Recall Bulletin

SUBJECT: Power Seat Wiring Harness Chafing

MODELS: 2013 Chevrolet Malibu
Equipped with 8-Way Power Front Seat Feature (AG1/AG2) and without
Memory Seat Feature (A45)

3642508

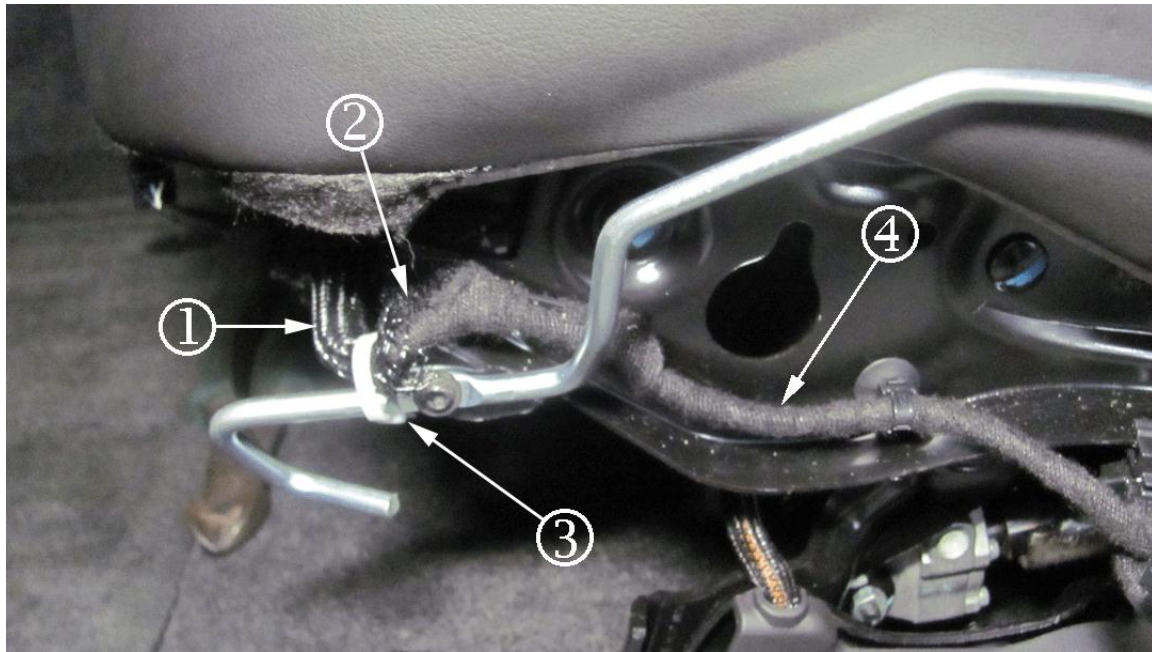
Note: On certain 2013 model year Malibu vehicles with the non-memory power seat option, the wiring harness may wear against the seat frame. Inspect the seat wiring harness on vehicles equipped with driver seat RPO AG1-A45 or passenger seat RPO AG2. Wire harness abrasion occurs at the forward, outboard frame on either driver or passenger seat. Refer to the photograph to review the area (1) to examine.

1. Determine if the driver and/or passenger seat must be inspected by reviewing seat RPO information.
2. Remove the driver and/or passenger seat outer recliner finish cover (2). Refer to *Driver or Passenger Seat Outer Recliner Finish Cover Replacement* in SI.

3642530

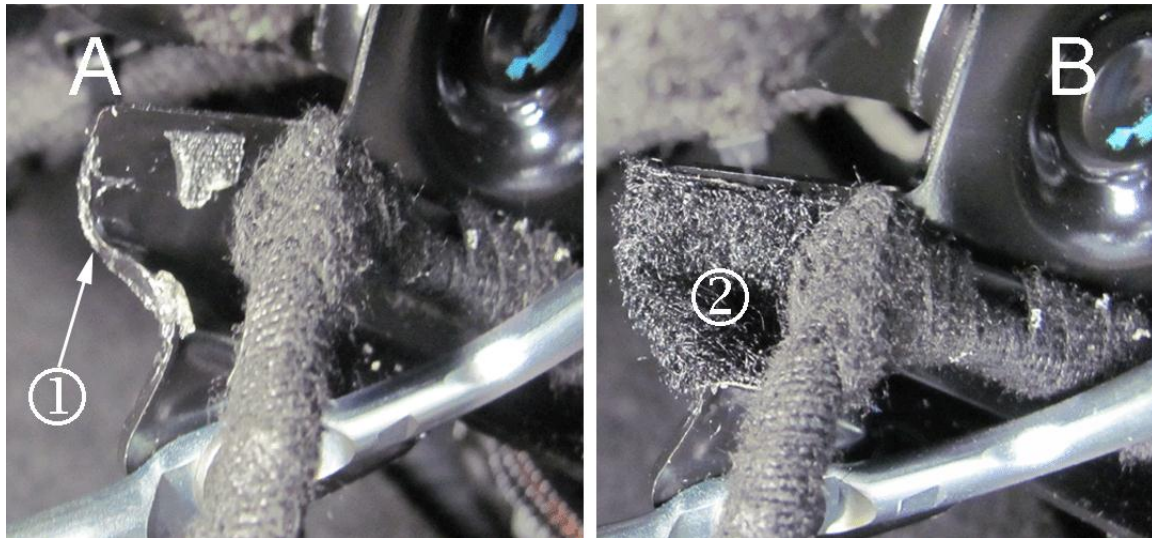
3. Examine the seat wiring harness (4) to determine if it has a harness protector (1), tie strap (3) and Velcro tape patch (2) on the front edge of the seat frame.
 - If the harness protector, tie strap and Velcro tape patch are present, no further action is required. Install the driver and/or passenger seat outer recliner finish cover. Refer to *Driver or Passenger Seat Outer Recliner Finish Cover Replacement* in SI.
 - If the harness protector, tie strap and Velcro tape patch are NOT present, proceed to step 4.
4. Inspect the seat wire harness wrapping for damage. If the wiring insulation becomes worn or cut through to the conductor a short to the grounded seat frame may occur. Repair wire harness, if necessary. Refer to the appropriate wire repair procedures in SI.

5. Cut a 25 mm (1 in) piece of Velcro tape. Use the loop side of the tape for the repair.

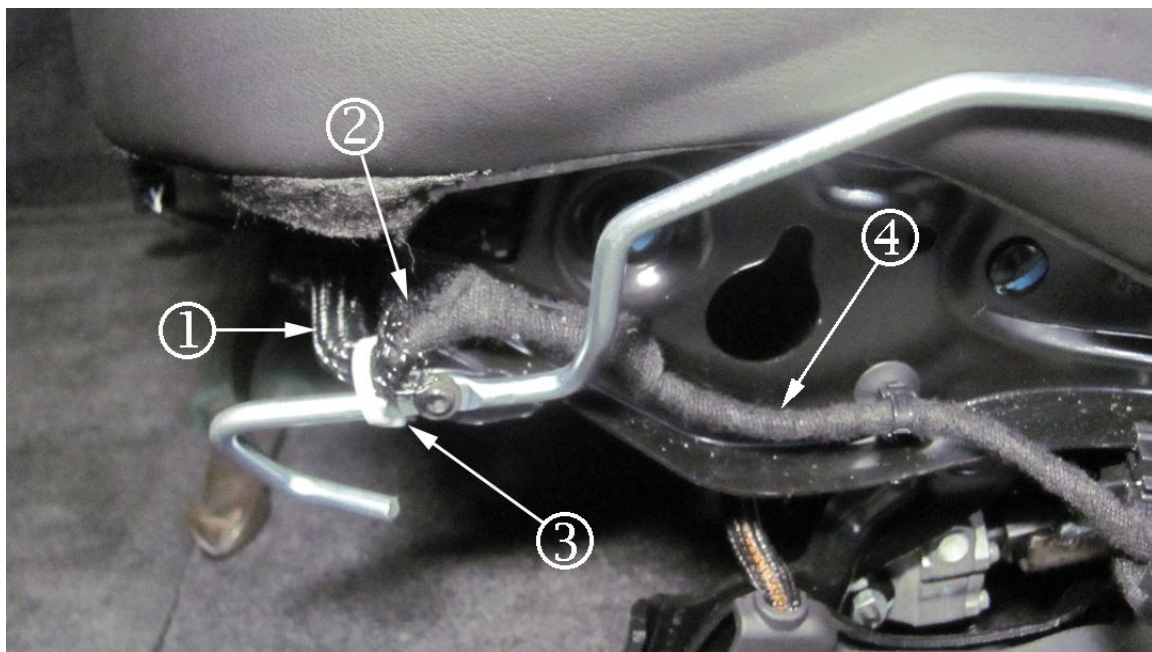
6. Apply the loop side of the Velcro tape (2) around the seat frame edge (1) as shown in photograph. 'A' portion of photograph shows a seat frame edge without Velcro tape. The 'B' portion of the photograph shows the Velcro tape applied to the seat frame edge.

7. Wrap the protector sleeve (1) round the wire harness (4) in the area that will come in contact with the seat frame edge.
8. Install the tie strap (3) around the wire harness (4) and metal bar to secure the protector.
9. Cycle the front seat height and tilt adjustment 3 full times and inspect afterwards that the reworked area is still intact.
10. Install the driver and/or passenger seat outer recliner finish cover. Refer to *Driver or Passenger Seat Outer Recliner Finish Cover Replacement* in SI.
